Subject: **RZ 16-021:** CQ Dunwoody Village Court, LLC, owner of 1530 and 1536 Dunwoody Village Parkway, Dunwoody, GA 30338, by Marian Adeimy, attorney for contract purchaser, seeks to rezone property currently zoned Office-Institution (O-I) District to Multi-dwelling Residential-100 (RM-100) District to allow for construction of a 79-unit townhome development. The tax parcels are 18 366 06 061 and 18 366 06 065 respectively.

The applicant seeks approval to rezone both parcels from Office-Institution (O-I) District to Multi-dwelling Residential-100 (RM-100) District to build a 79-unit townhome development.

ZONING PLAN

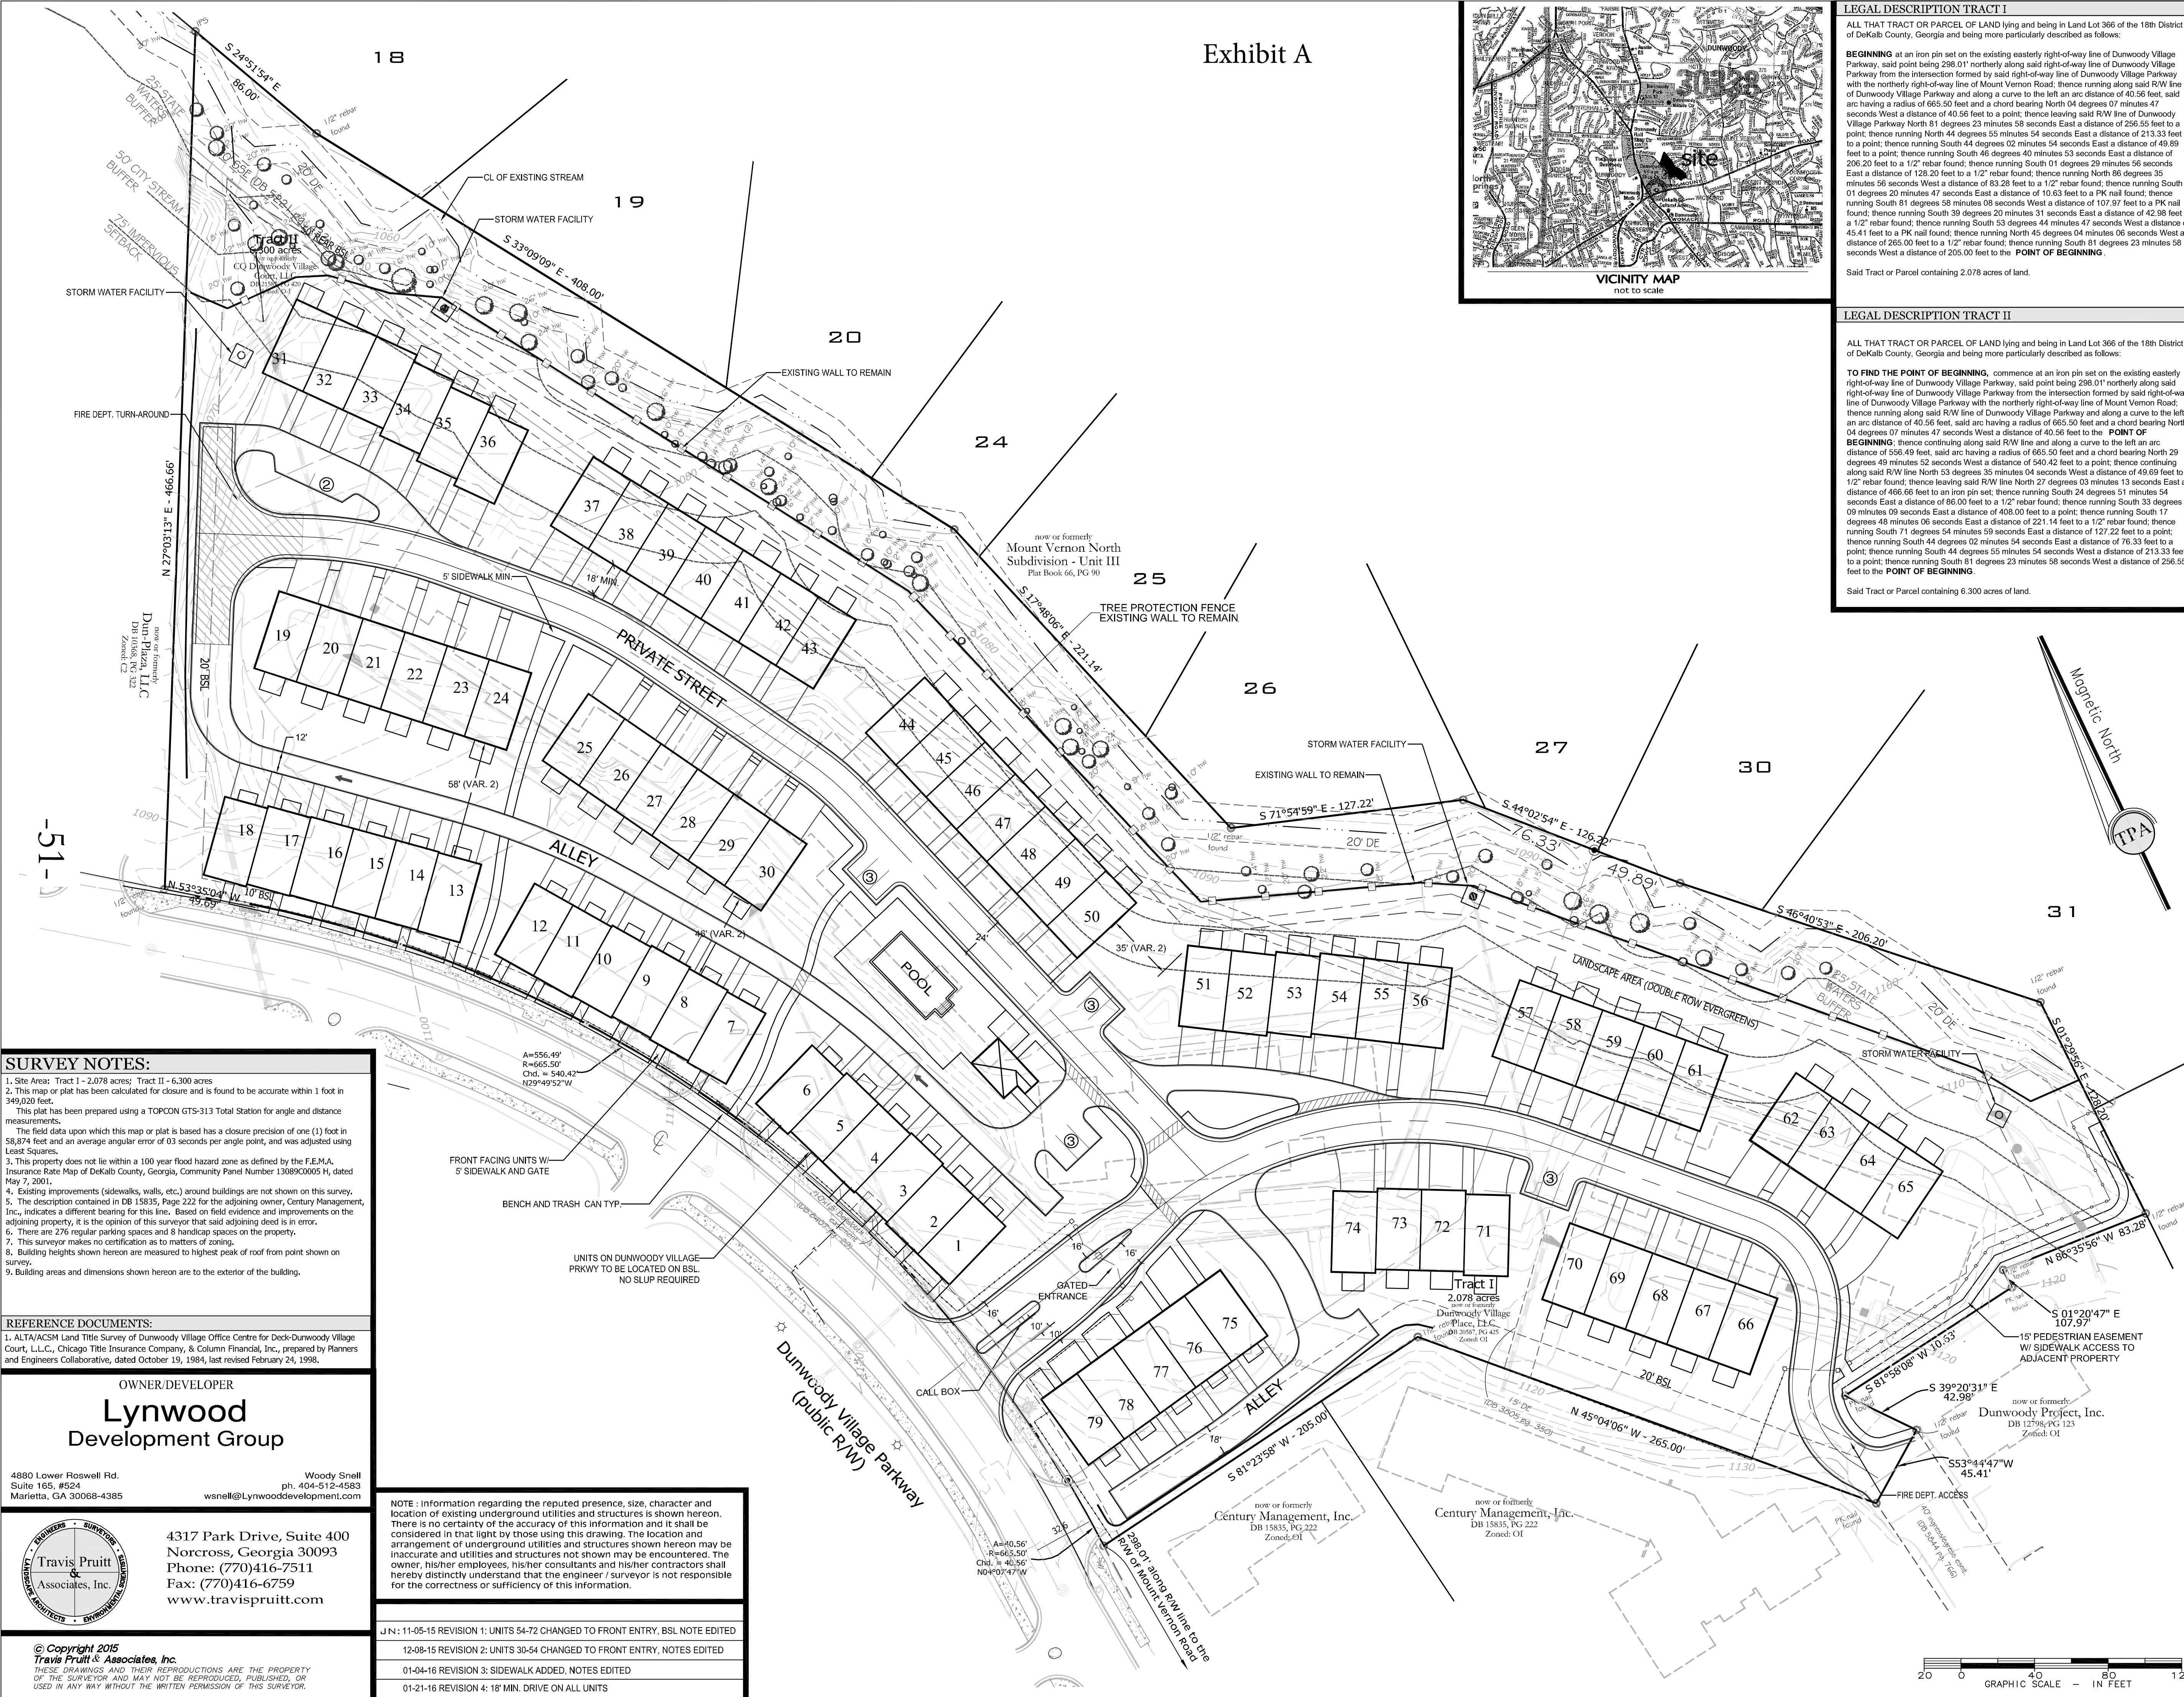
According to the site plan dated January 21, 2016, the developer proposes to construct 14 multi-unit buildings, containing a total of 79 units on 8.34 acres for an overall density of 9.4 units per acre. The maximum allowed density is 12 dwelling units per acre. The number of units in a building ranges from four to seven. Buildings with seven units will be approximately 180 feet long. The maximum building length allowed is 250 feet. Rear-loaded and front-loaded units are proposed. Units along Dunwoody Village Parkway will front on the Parkway but be rear-loaded; all other units will be front-loaded. Two dimensions of units are proposed: units with master on main will be approximately 32 feet wide, and units without master on main will be approximately 24 feet wide. All units are proposed to be 44 feet deep. Master on main units may be front-loaded or rear-loaded. The applicant has stated units will be a maximum of three stories in height.

Interior private drives are 24 feet wide. There are two main alleys: a 12 foot wide one-way alley behind units 1-18 that runs south to north, and an 18 foot alley behind units 75-79. Two-car garages with carriage-style garage doors will be standard. A total of fourteen guest parking spots are provided. Ten guest parking spaces are required. All driveways will be a minimum depth of 18' as approved by the Zoning Board of Appeals.

The Pedestrian Circulation Plan shows five-foot wide sidewalks, which provide direct access to nine of the buildings. Sidewalks are provided on one side of the main private drives. No sidewalks are provided in the alleys. Of the 79 units, 33 units do not have direct access to a sidewalk. Units that front Dunwoody Village Parkway have pedestrian access to the sidewalk along the Parkway. A pedestrian easement is provided for the Vernon North Subdivision to Mt. Vernon Road. Staff is recommending it connect to Dunwoody Village Parkway.

Having received variances necessary to bring several deficiencies into compliance, the site plan appears to be in compliance with all zoning regulations. Staff has asked the applicant to verify that the side-to-side building separations are 20 feet at units 6-7, 12-13, 24-15, but those measurements have not been provided.

1. Development shall be in substantial compliance with Exhibit A. If the SLUP is not approved, the site plan shall be adjusted to accommodate the additional six feet of sidewalk width. Adjustments shall be processed in accordance with Section 27-337, which defines major and minor changes.
